AMENDMENT NO. 2 NOVEMBER 2024

**IS 16192 (PART 3) : 2018 AUTOMOTIVE VEHICLES — WHEEL RIMS FOR TWO
AND THREE WHEELED VEHICLES**

PART 3 SPOKE WHEEL RIMS — METHODS OF TESTS AND REQUIREMENTS

FIG. 1 LOAD APPLYING METHOD

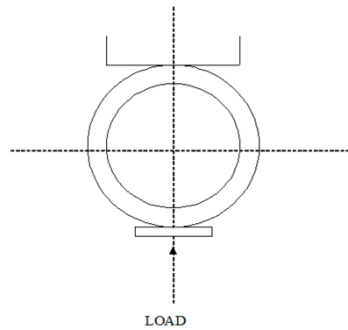
(Page 1, clause 4.2) — Substitute the following for the existing:

‘4.2 Strength Requirements

4.2.1 Load Applying Method

Place the rim vertically on the base having a plane of not smaller than a horizontal rim width and add the load gradually, as per Fig. 1 to the rim, toward the direction of vertical centre of rim from the most outside circumference part of rim.

4.2.2.1 When the deflection of wheel rims (without wired spokes) has attained a value given in Table 1 by applying a load by the method given in Fig. 1 to the rim, the load shall not be smaller than the value given in Table 2 and in addition, the rim shall be free from cracks.

4.2.2.2 For the sizes not available in Table 1 and Table 2, when the deflection of wheel rims (without wired spokes) has attained a value as declared by wheel rim manufacturer, applying a load by the method given 4.2.1 to the rim, the load shall not be smaller than the value declared by wheel rim manufacturer and in addition, the rim shall be free from cracks.

FIG. 2 CYLINDRICAL BEAD SEAT RIM CONTOURS

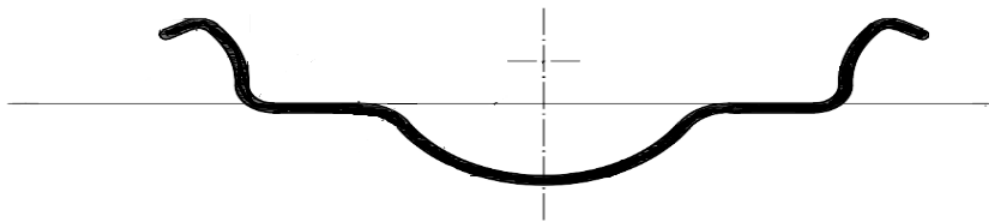
4.3 Rim Contour (For Reference Only)

4.3.1 Cylindrical Bead Seat

A rim contour for cylindrical bead seat rim is given at Fig. 2.

FIG. 3 5° TAPERED BEAD SEAT RIM CONTOURS (MT TYPE)

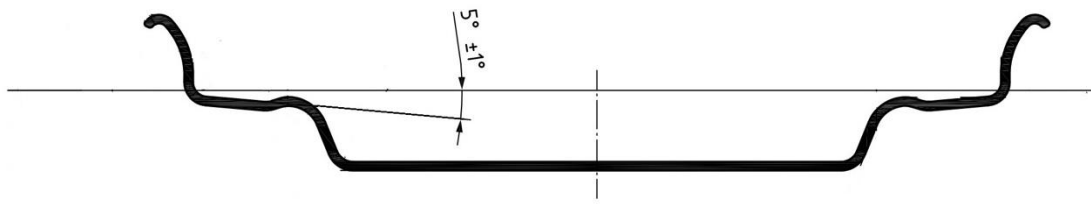
4.3.2 Tapered Bead Seat Rims (MT Type)

4.3.2.1 Rim contour for 5° tapered bead seat rim with hump is given in Fig. 3, rim contour for tapered bead seat rim with hump and well contour is given in Fig. 4 and rim contour for tapered bead seat rim without hump is given at Fig. 5.
